# SERVICE BULLETIN

**TITLE: STABILIZERS - INSPECTION/REPLACEMENT OF ELEVATOR BALANCE WEIGHT ASSEMBLIES**

Model 58, Baron, Serials TH-1768 through TH-2110.

**Inspection of Elevator Balance Weight Assembly  
Figure 1**

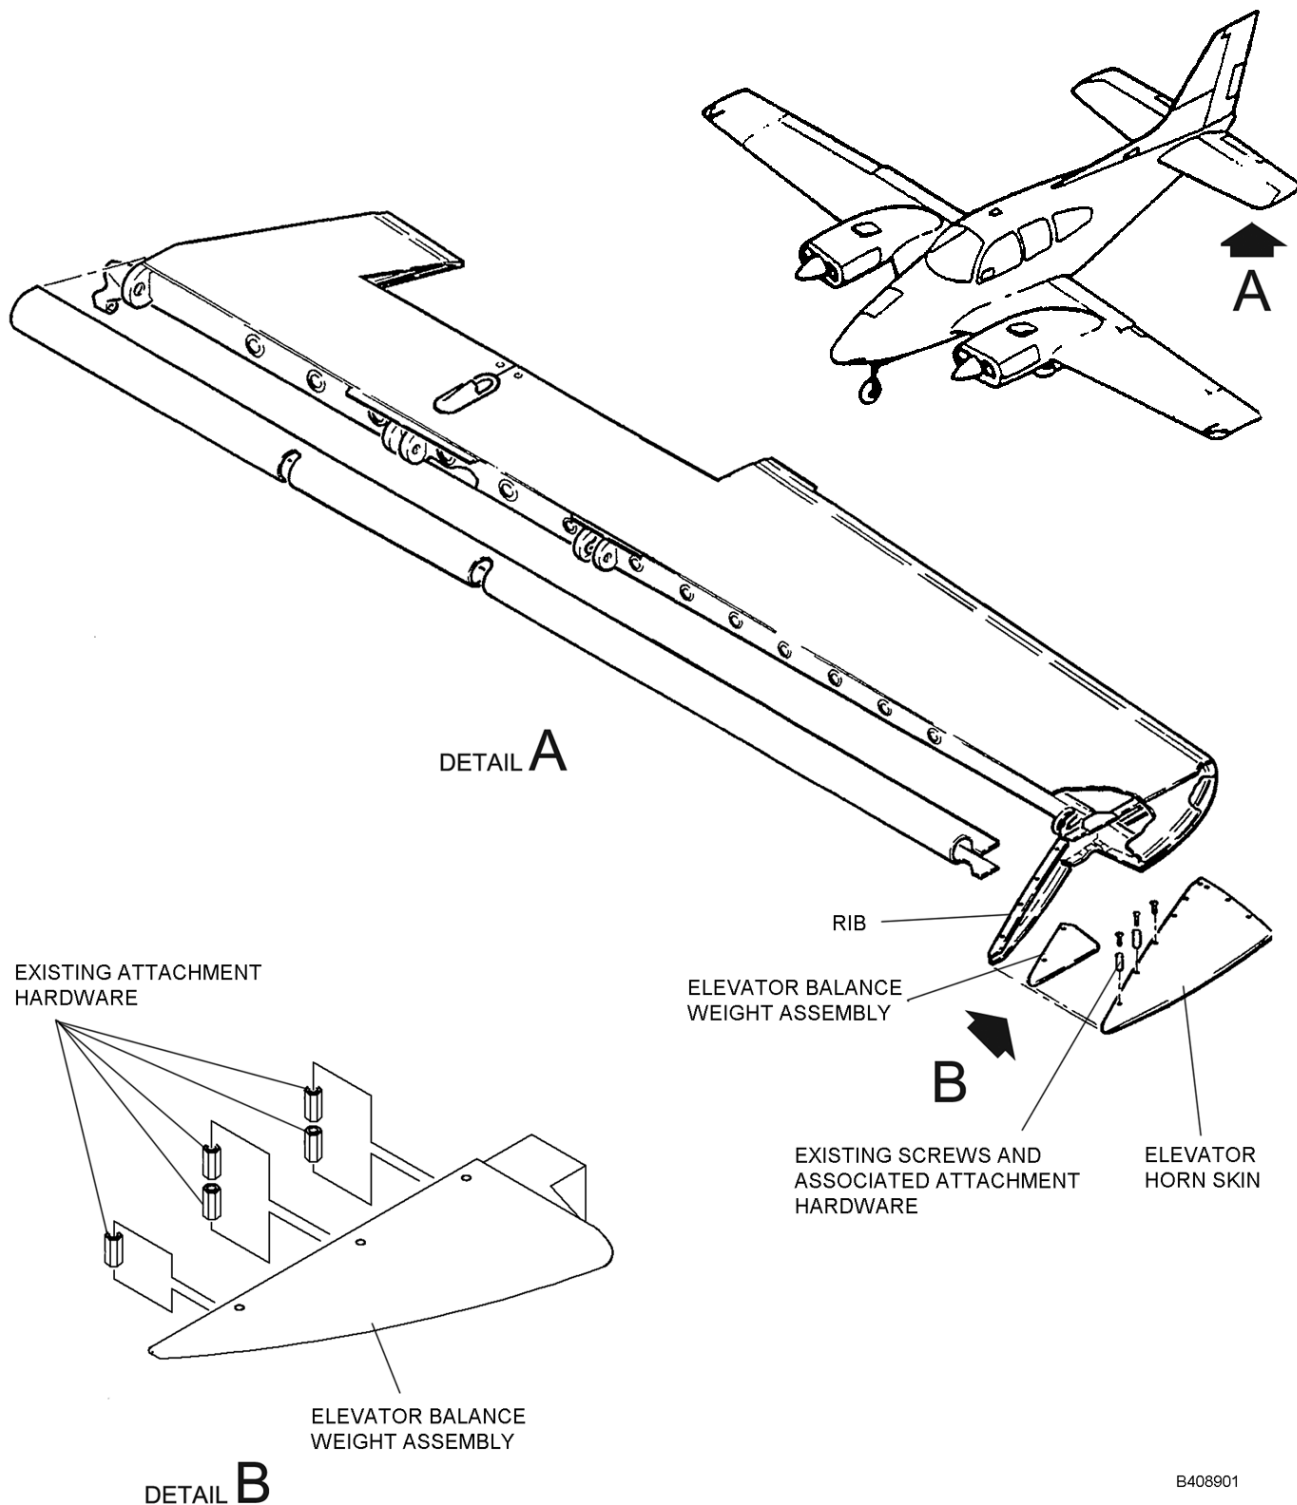
- (2) Gain access to the elevator and locate the existing elevator balance weight assembly that is installed under the elevator horn skin. Refer to Figure 1 and Figure 2.

- (3) Visually inspect to determine if the existing elevator balance weight assembly is in position and protruding from the edge of the rib. In addition, verify that the elevator balance weight assembly attachment screws on upper and lower surfaces are secure and the installation holes show no sign of discoloration. Refer to Figure 1 and Figure 2.

- (a) If the existing elevator balance weight assembly is in position, protruding from the edge of the rib, the attachment screws are secure and the installation holes show no sign of discoloration, no further action is required for this Service Bulletin. Proceed to Step (13).

- (b) If the existing elevator balance weight assembly has become dislodged, the attachment screws are not secure, or the installation holes show signs of discoloration, proceed to Step (4).

**Inspection of Elevator Balance Weight Assembly**  
**Figure 2**

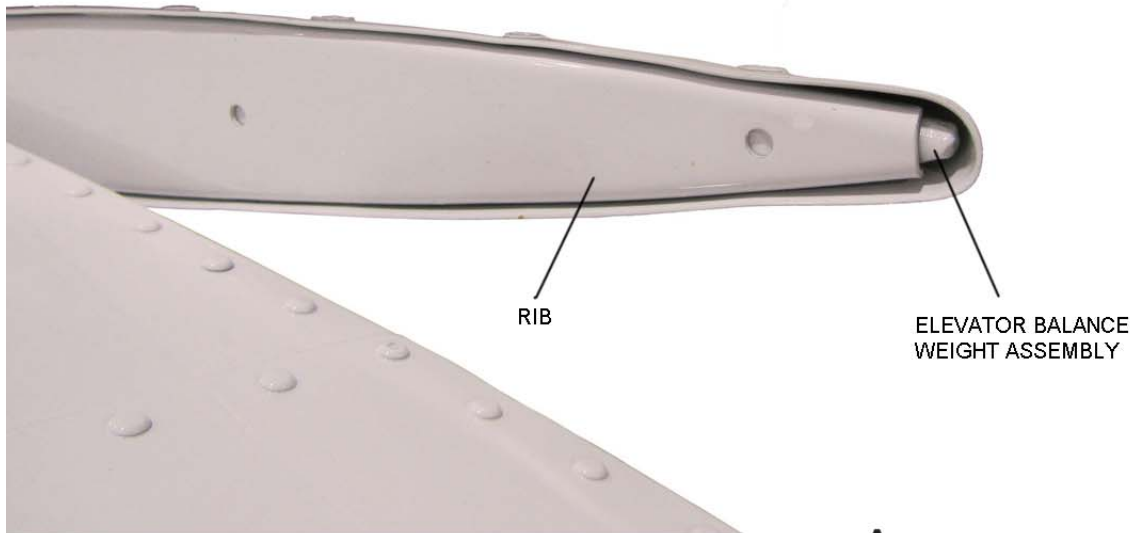
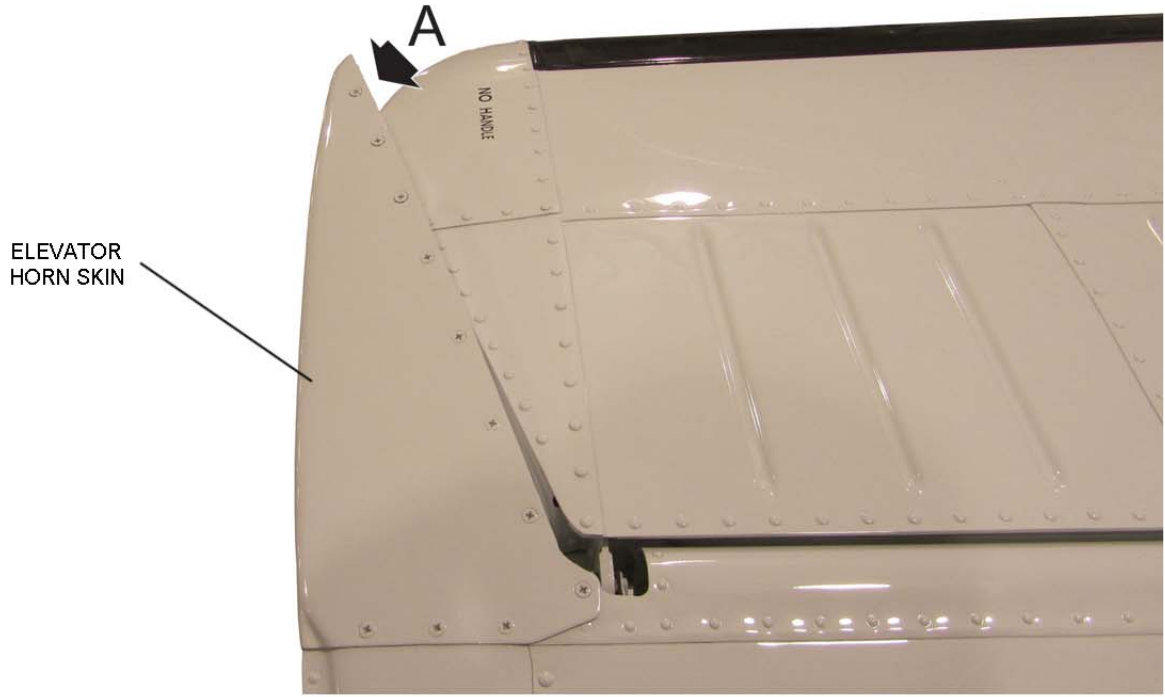
- (7) Use the screws and associated attachment hardware that were retained in Step (4) to install the applicable new elevator balance weight assembly. **Note:** New hardware may be used as necessary, as defined in Paragraph 2.C.2. The installed elevator balance weight assembly shall protrude from the rib as shown in Figure 2.
